McCULLOCH CORPORATION
SERVICE BULLETIN

1502

MODEL: CP 55, CP 70, MM 6 March 19, 1971

SUBJECT: BRACKET KIT SCREWS, IGNITION SWITCH

Mini-Mac 6 - Ignition Switch

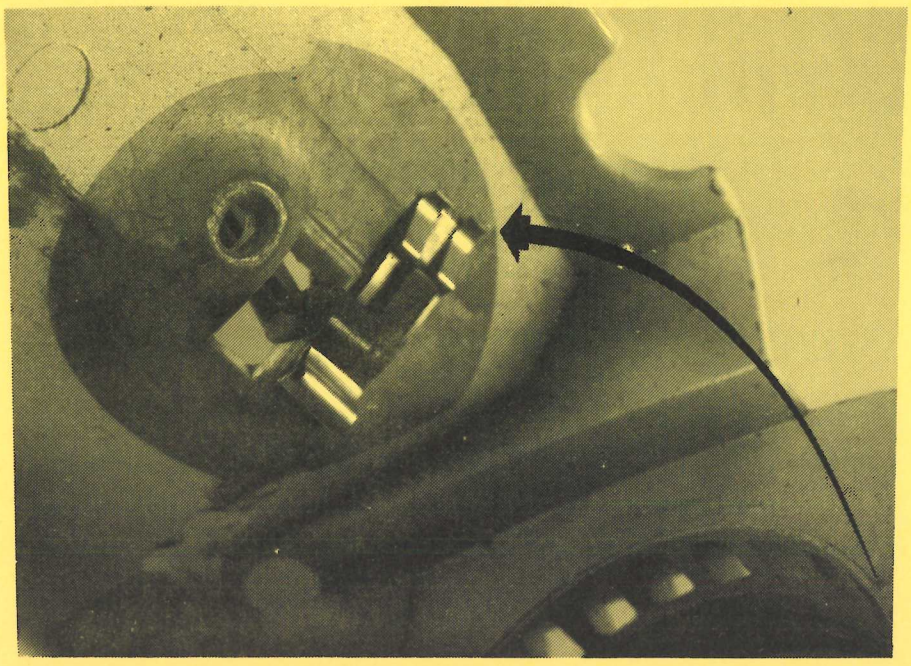
On some units of the Mini-Mac 6 (manual models) in the serial number range of 28015 to 30000, it has been noted that the ignition switch will not remain in the "on" or run position. The reason for this condition is that there is interference between the switch contact and the fuel tank when the button is pushed to the "on" position.

The problem may be eliminated by bending the forward tips of the contact down flat against the fan housing. See illustration below.
